**SUBDIVISION,
PLANNED UNIT DEVELOPMENT
& SIDEWALK WAIVER REQUEST
STAFF REPORT****Date: October 3, 2013**

<u>NAME</u>	Halls Mill South Industrial Park Subdivision, Resubdivision and Addition to Lot 5
<u>SUBDIVISION NAME</u>	Halls Mill South Industrial Park Subdivision, Resubdivision and Addition to Lot 5
<u>LOCATION</u>	5113 Halls Mill Road (East side of Halls Mill Road, 2/10 \pm mile South of Demetropolis Road)
<u>CITY COUNCIL DISTRICT</u>	District 4
<u>PRESENT ZONING</u>	I-1, Light Industry District
<u>AREA OF PROPERTY</u>	1 Lot / 0.6 \pm Acre
<u>CONTEMPLATED USE</u>	Subdivision approval to create one legal lot of record, Planned Unit Development approval to allow multiple buildings on a single building site and Sidewalk Waiver approval to waive construction of sidewalks along Halls Mill Road.
<u>TIME SCHEDULE</u>	None specified

SITE PLAN

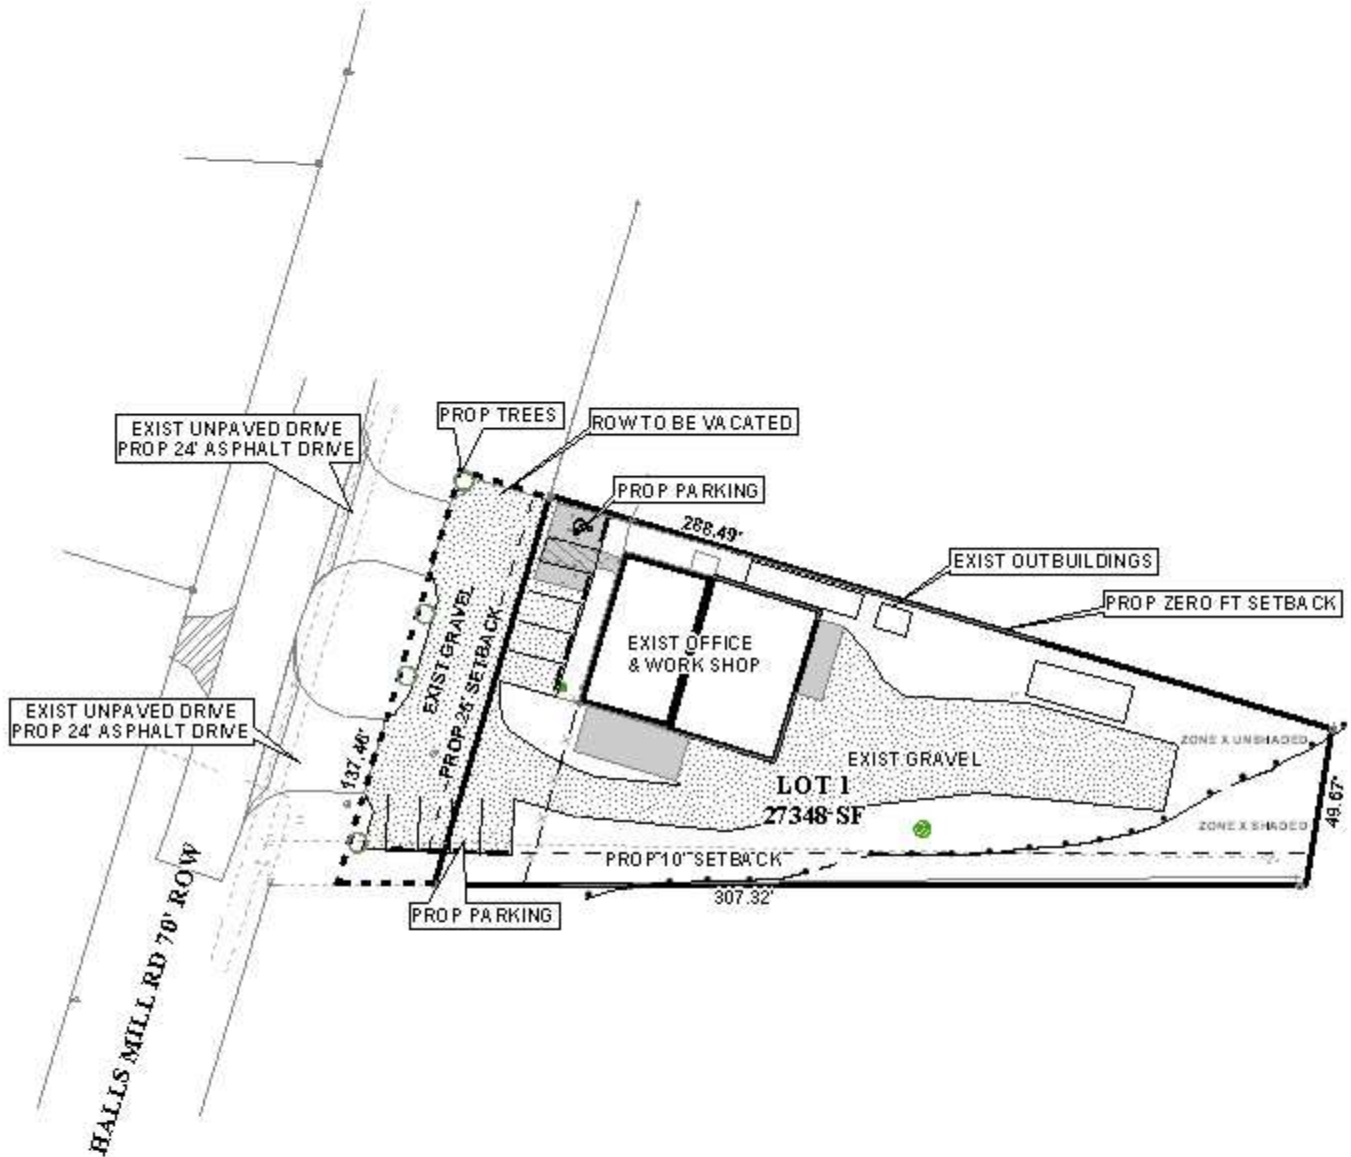
The site is currently non-compliant with regard to access, surfacing, parking, setbacks, and landscaping and tree plantings. Some compliant improvements are proposed. However, the site plan indicates some noncompliant aspects are to remain and also an expansion of the noncompliance within the expanded frontage area is proposed

The site plan indicates a compliant number of parking spaces in front of the office building but with the existing gravel surfacing to remain. With the exception of the proposed handicap parking space, which will be paved, the applicant proposes to pave with asphalt the entrance drives, and requests to leave the gravel for the remainder of the parking area. As modifications to the front area have previously been mentioned to obtain landscaping ratio compliance and curb cut/access compliance, it would stand that at least the front parking area should also be brought into compliance with paving. Therefore, the site plan should be revised to eliminate the Northern curb cut and drive, provide the required front yard landscaping ratio, and to remove

As the site is zoned I-1, four over-story frontage trees would be required and are so indicated on the site plan. A gate is indicated even with the front face of the office building at approximately 56' from the proposed new right-of-way line after vacation. As the Zoning Ordinance requires a 60' queuing distance from the public right-of-way, this gate should either be relocated further back to provide such, or a note should be placed on the site plan stating that the gate is to remain open during all normal office hours.

The site plan indicates a compliant 10' minimum building setback along the South line of the property adjacent to the residential zoning and use to that side. This should be retained on the revised site plan. A zero setback is requested along the North and East sides of the property. Since adjacent properties on those two sides are zoned I-1, a zero setback with proper fire-rated walls or 5'-plus setback is allowed. However, the site plan indicates that the air compressor shed, the metal storage container, and the 100 square-foot shed all encroach within the 5' setback. Therefore, the site plan should be revised to indicate compliance with either a zero setback with proper fire-rated walls, or a 5' minimum side setback.

- 1) revision of the site plan to eliminate the Northern curb cut and drive;
- 2) revision of the site plan to provide the minimum required front yard landscaping ratio;
- 3) revision of the site plan to remove the gravel surfacing within the front parking area and provide asphalt, concrete, or an approved alternative paving surface;

- 4) provision of four over-story frontage trees as indicated on the site plan;
- 5) revision of the site plan to relocate the gate on the drive to the rear to a compliant 60' queuing setback from the new right-of-way line, or the placement of a note on the site plan stating that the gate is to remain open during all normal office hours;

- 8) revision of the site plan to indicate a compliant zero setback with fire-rated walls or a 5' minimum setback along the North line for the air compressor shed, metal storage container, and the 100 square-foot shed;

SIDEWALK CROSS SECTION DETAIL

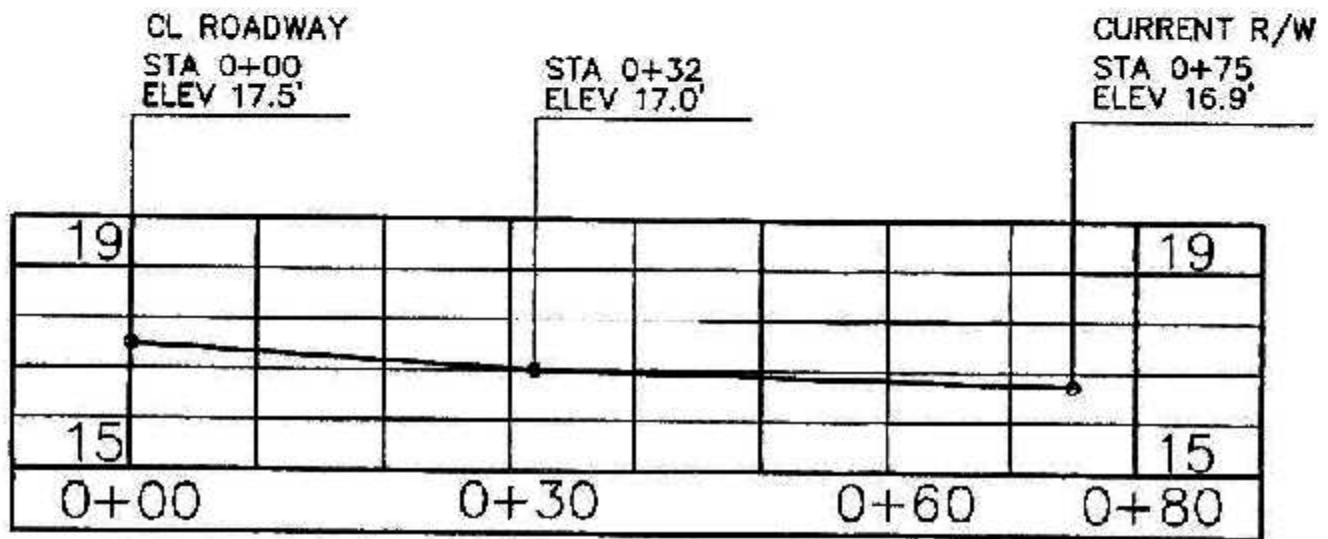
Sidewalk Waiver: It appears that there is sufficient room within the ROW, or within the property, for the construction of a sidewalk.

Regarding the Sidewalk Waiver request, the applicant states the sidewalk should not be required along Halls Mill Road as there are no existing sidewalks within a one-mile radius of the site. It is further stated that an existing storm water drainage headwall and sewer manhole are located in the right-of-way close to the existing roadway asphalt which would make construction of a sidewalk difficult in this area. It should be noted that a Sidewalk Waiver was denied for a site on Halls Mill Road just 3/10 mile± East of the subject site and a sidewalk was constructed. A sidewalk waiver was granted for a site on the West side of Halls Mill Road approximately 250' North of the subject site due to an open drainage system and lack of useable neutral ground within the right-of-way. However, even after vacation, the subject site would appear to have adequate space within the remaining right-of-way away from the mentioned drainage headwall and sewer manhole to provide a sidewalk within relatively flat terrain.

Sidewalk Waiver: Based on the preceding, it is recommended that this application be denied.
